LOST CREEK ISR, LLC

November 11, 2010

**Re: Lost Creek Project, Requested Clarifications
Docket No. 40-9068
TAC No. LU0142**

NRC TECHNICAL REPORT LOST CREEK PROJECT INDEX SHEET FOR CHANGES			Date: 11/11/2010
			Docket No.: 40-9068
			TAC No.: LU0142
TR VOLUME NUMBER	PAGE, MAP OR OTHER PERMIT ENTRY TO BE REMOVED	PAGE, MAP OR OTHER PERMIT ENTRY TO BE ADDED	DESCRIPTION OF CHANGE
1 of 4	Pages i through xxiv	Pages i through xxiv	Updated overall Table of Contents.
	<i>Section 2.5 - Meteorology, Climatology and Air Quality</i>		
	Page 2.5-i	Pages 2.5-i and 2.5-ii	Updated section Table of Contents
	Pages 2.5-1 through 2.5-6	Pages 2.5-1 through 2.5-7	Text added in response to discussion with NRC personnel.
	--	Attachment Tab	Tab added for new attachment.
2 of 4	--	Attachment 2.5-1	Attachment added to verify that the short-term meteorological data used to compare the LC site to the Rawlins station were representative of the long-term Rawlins meteorology.
	Pages i through xxiv	Pages i through xxiv	Updated overall Table of Contents.

Figure 1. Comparison of Average Daily Temperatures (Degrees Fahrenheit)

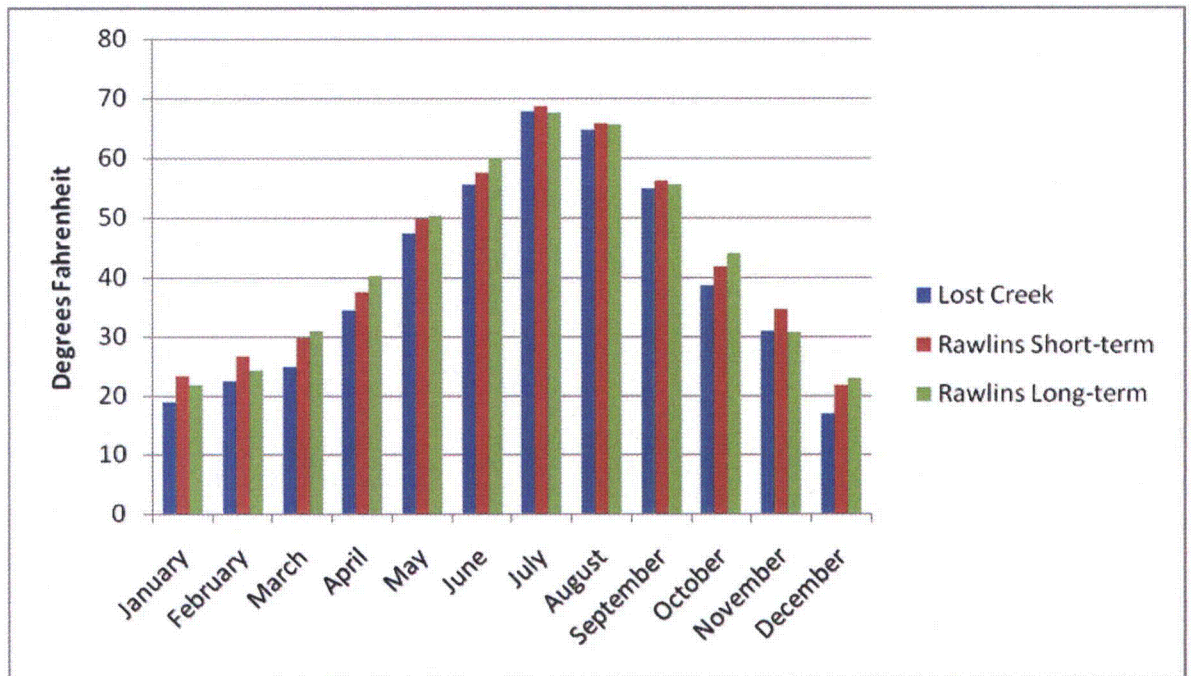
The average daily temperatures for each month during 2007 – 2009 at Lost Creek and Rawlins are presented in **Table 2**. On average, Rawlins was slightly warmer than Lost Creek during this time period; however, average daily temperatures at Lost Creek and Rawlins are in the same range, i.e., within the 95% confidence intervals for the two data sets to overlap. The confidence intervals (CIs) are defined as the mean of the data set $\pm 2 \times$ the Standard Error (SE), where $SE = \text{STDV} / \text{square root of number of samples (N)}$. Variations in daily temperatures during all months are very similar. Average daily temperatures for Lost Creek and Rawlins (short-term and long-term) are presented in **Figure 1**.

Figure 2. Comparison of Average Daily High Temperatures (Degrees Fahrenheit)

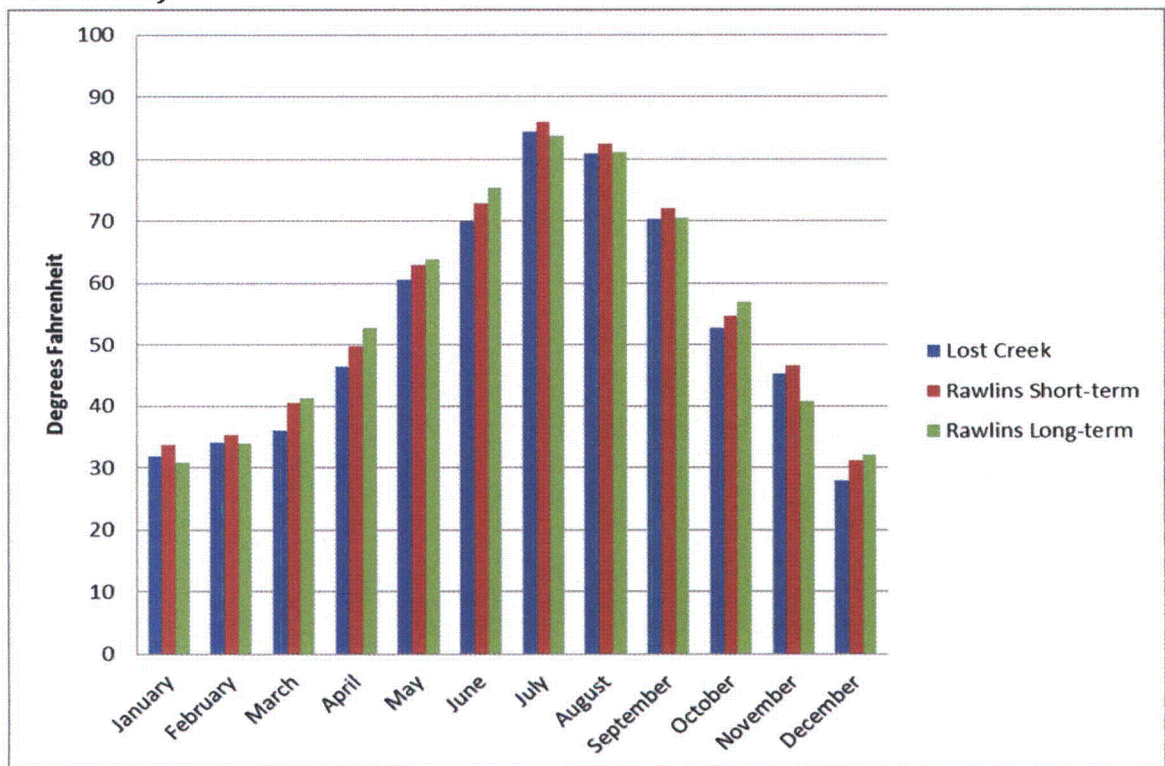
The average daily high and low temperatures each month for the short-term Lost Creek and both the short-term and long-term Rawlins station data are presented in **Figure 2** and **Figure 3**, respectively, and in **Table 3**. Again, highs and lows measured at the Rawlins station over the short-term were generally a few degrees warmer than those measured at the Lost Creek station, but both high and low average daily temperatures were generally within the same range, as indicated by the overlap of the majority of the 95% CIs. One exception to this is the slightly more extreme low temperatures observed during the winter months at the Lost Creek station. These data also demonstrate that the short-term Rawlins data are statistically very similar to the long-term Rawlins temperature data and can be considered representative of the long-term temperature record.
